HOLIDAY INN
RIVERSIDE ST.
PORTLAND, ME.

APPLICATION FOR PERMIT

MEMORANDUM FROM DEPARTMENT OF BUILDING INSPECTION, PORTLAND, MAINE

General construction permit for proposed Holiday Inn at the above named location in this City is issued herewith to contractor based on revised plans and specifications filed at this office on August 23, 1963, but subject to the following conditions:

REMOVE EXISTING FAN, INSTALL ADJUSTABLE-DRAFT FAN FOR AIR INTAKE

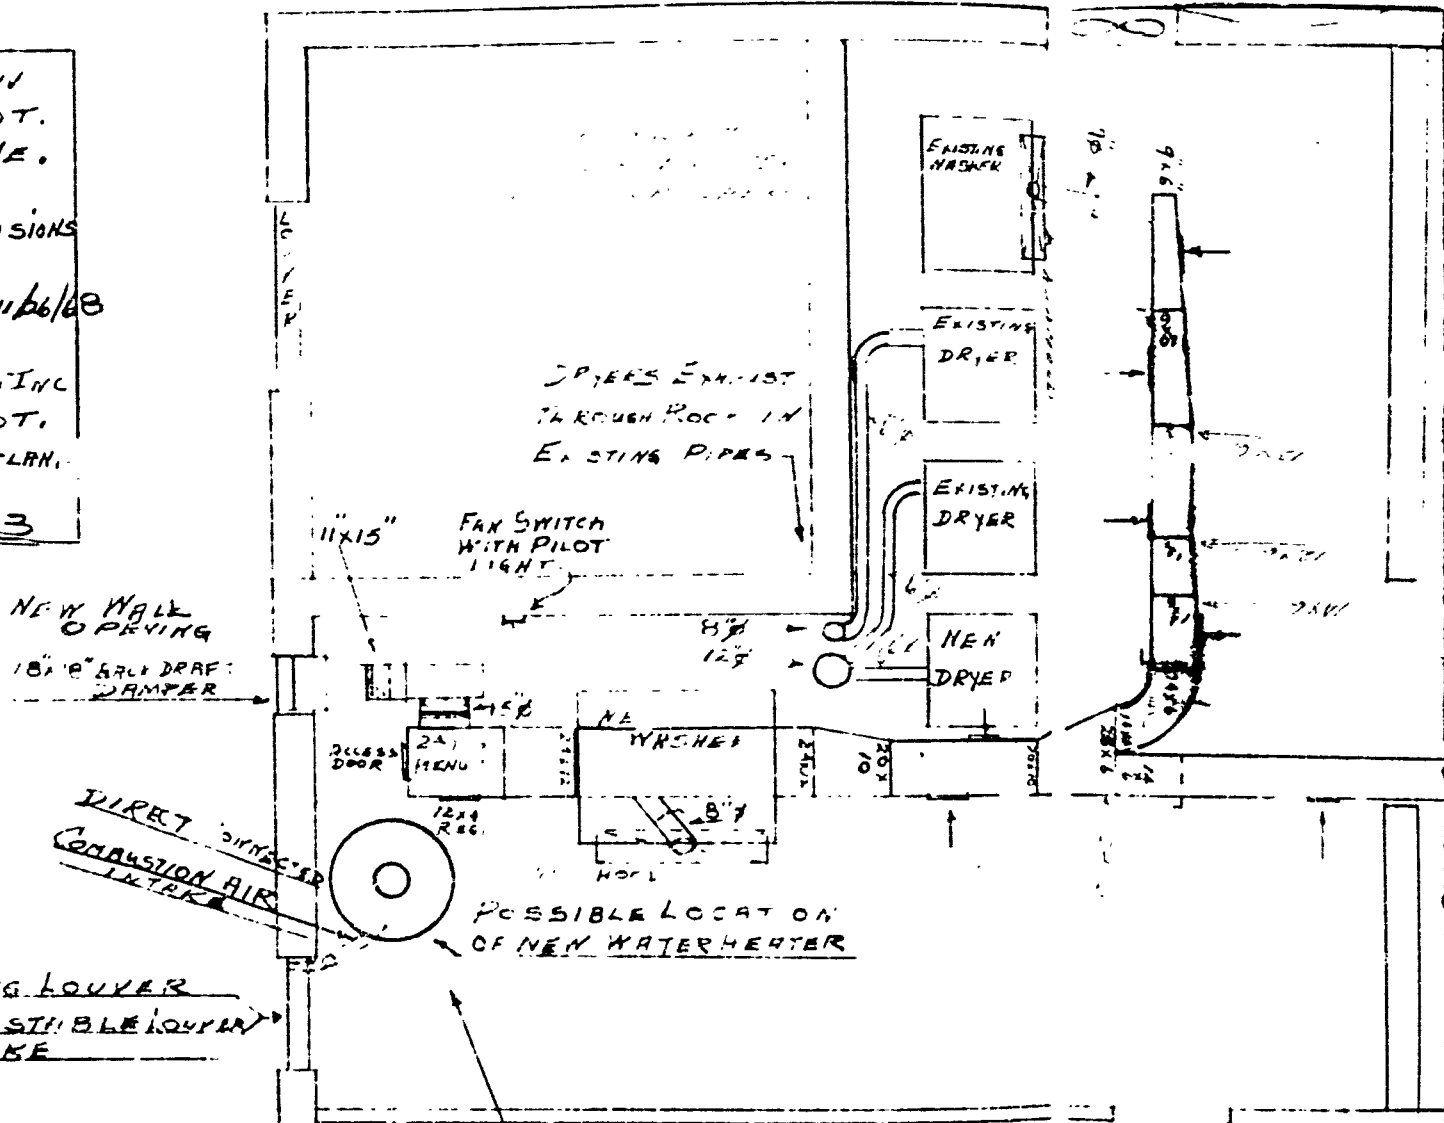
NEW WATER HEATER
WILL REQUIRE NEW
ROOF OPENING,
FLASHING, COUNTER
FLASHING, ROOF COLLAR,
METAL BESTOS FLUE,
BELMONT TOP AND
POSITIVE DRAFT
DIVERTER. ALSO
POSITIVE COMBUSTION AIR
2\"/>
